Product Change Notification

Product Change Notification: E-19-014888

RECEPTACLE HOUSING MICRO MNL, DOUBLE AND SINGLE ROW.

NEW DASHES ADDED AND DASHES ACTIVATED TO PRELIMINARY STATUS. There have been no changes to the existing parts, the drawings have been modified to show a new product offering.

RECEPTACLE HOUSING, 2 TO 24 POSITION, DUAL ROW, MICRO MATE-N-LOK™

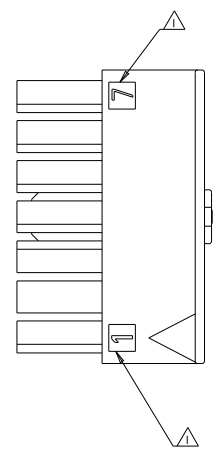
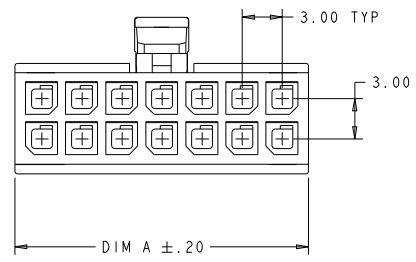
- △ CIRCUIT IDENTIFIER, LOCATED APPROXIMATELY AS SHOWN.
- △ DIMENSION ONLY 7.56 ON 2 POSITION.
- △ MATERIAL PA66/6 UL94-V0.COLOR-BLACK
- △ PRELIMINARY MATERIAL PA6, UL94-V0
- △ MATERIAL PA66 UL94-V0, GW .COLOR-NATURAL
- △ PRELIMINARY PART NOT RELEASED FOR PRODUCTION.
- △ MATERIAL ID ">PA<" LOCATED IN APPROX AREA SHOWN, APPROX 0.01 HIGH.

PNS TO BE REACTIVED.

TE Connectivity
 RECEPTACLE HOUSING,
 2 TO 12 POSITION, SINGLE ROW,
 MICRO MATE-L-LOK(TM)

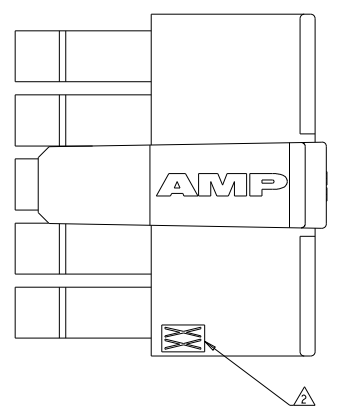
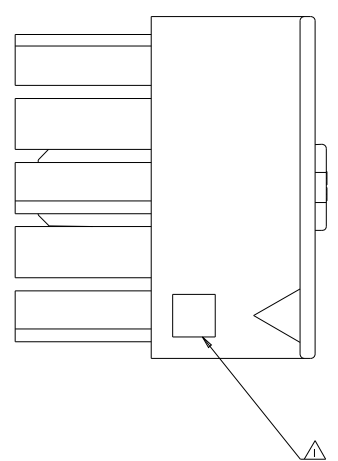
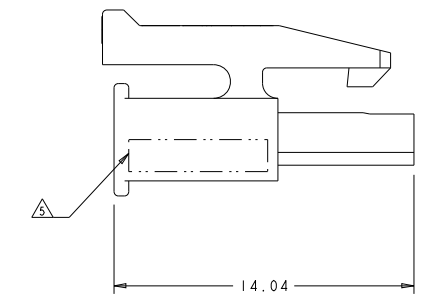
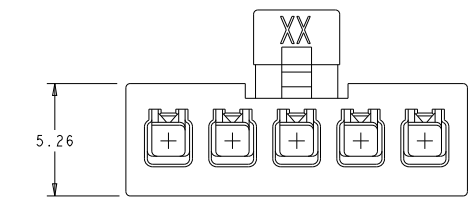
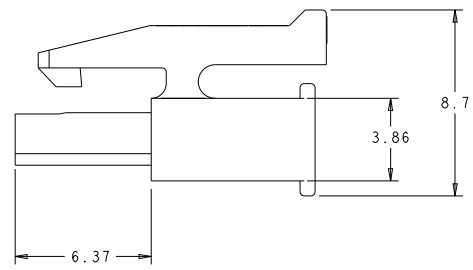
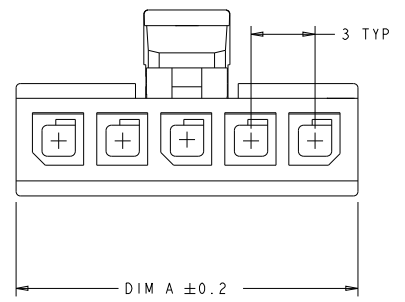
- △ CIRCUIT 1 IDENTIFIER, LOCATED APPROXIMATELY AS SHOWN.
- △ LAST CIRCUIT IDENTIFIER, LOCATED APPROXIMATELY AS SHOWN.
- △ MATERIAL PA66/6 UL94-V0. COLOR - BLACK
- △ PRELIMINARY MATERIAL PA66 UL94-V0 GW. COLOR - NATURAL
- △ MATERIAL ID ">PA<" LOCATED IN APPROX AREA SHOWN, APPROX 0.01 HIGH.
- △ PRELIMINARY PART NUMBER NOT RELEASED FOR PRODUCTION
